Blues Point Access Site Modification 8

Response to Submissions Report

Author:	Sydney Metro
Date:	September 2020
Version:	1
Reference:	SM-20-00092772

Figure 1 Construction access constraints

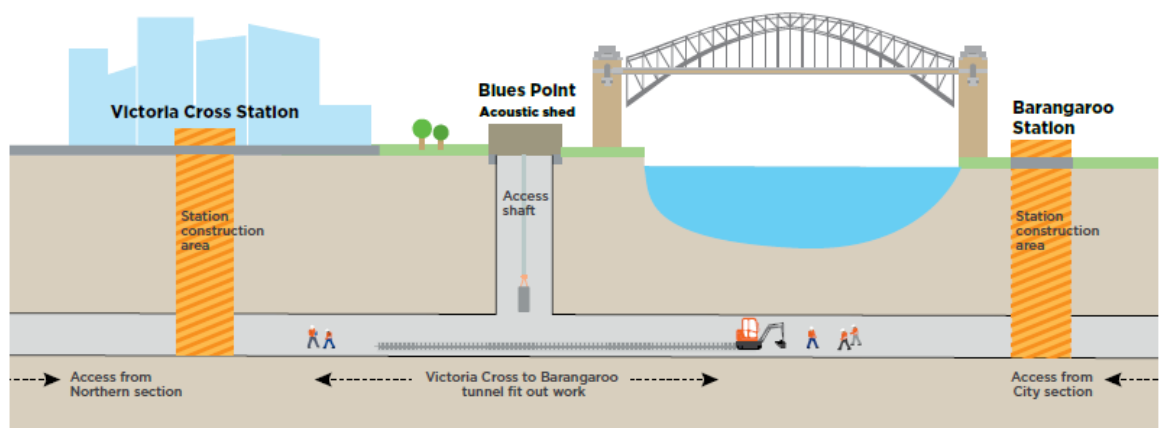
7	<i>Project construction planning</i>	
7.1	<p>A number of clarifications and/or concerns were raised through submissions regarding the project construction planning and project schedule and the subsequent need to utilise Blues Point as an access point for tunnel fit out works. These included:</p> <ul style="list-style-type: none"> • requests to utilise Barangaroo site as the original preferred location for access for tunnel fit out works as per the original EIS and construction planning • the reason the restriction of access at Barangaroo and Victoria Cross to complete tunnel fit out was not previously known and questions why the use of Blues Point for tunnel fit out work was not included as part of the original application for use of the site, nothing that engineering design challenges and the archaeological finds made in 2018 would have been known to have created a delay and that the project knew earlier that the Blues Point site would be required for line-wide access. • Sydney Metro has had the opportunity to control other access points and that Sydney Metro has allowed design changes at Barangaroo which have rendered Barangaroo no longer viable. 	<p>The Blues Point temporary site has been identified as the required location for under-harbour tunnel fit out works as other tunnel access points on either side (such as Victoria Cross and Barangaroo) are being used for station construction. The original Barangaroo construction program was based upon a basic concept design. Changes throughout the design development phase, combined with the significant heritage find of Barangaroo Boat, have impacted the Barangaroo construction program and mean the site cannot be used for under-harbour fit out works as originally planned. Figure 1 shows the constraints in access from both Barangaroo and Victoria Cross.</p> <p>Figure 2 identifies the alternative access points considered for these fit out works.</p> <p>Some tunnel fit out activities are able to be undertaken from the Crows Nest Station construction site which has minimised the overall time Blues Point temporary site would be required. Rail will be delivered to Crows Nest Station to be welded before being placed along the length</p>

Item	Submission issue	Response
	<p>It was noted that the Modification Report did not address why development at Barangaroo was permitted to such an extent as to render alternative access shafts at Barangaroo unavailable.</p> <ul style="list-style-type: none"> • clarity on the delay at Barangaroo and how significant amount of time would be needed to recover the program • Barangaroo site is noted as a safer site due to the large construction site with existing safety infrastructure • options for creative engineering, planning and project management solutions should be considered to enable the use of the Barangaroo Site to avoid the continued use of Blues point for the proposed modification • the use of Blues Point site was identified by a Sydney Metro representative as 'more convenient' and that access at Barangaroo was difficult. • note that the Modification Report did not adequately address access from the Chatswood and Marrickville sites dive sites as outlined in the original Environmental Impact Statement • note that other Transport for NSW projects could be years late and that the delay would be acceptable if the Blues Point Reserve could be reinstated in 2020 • request for an independent review or clarification of the construction planning. 	<p>of the tunnels to Barangaroo. This tunnel fit out activity would be undertaken prior to access being blocked by the construction works at Victoria Cross Station. Once the rail is placed within the tunnels between Victoria Cross and Barangaroo, the remaining under-harbour tunnel fit out works are proposed to be undertaken from the Blues Point temporary site.</p> <p>Further details as to the alternative access locations considered were discussed in section 2.2.1 of the Modification Report.</p>
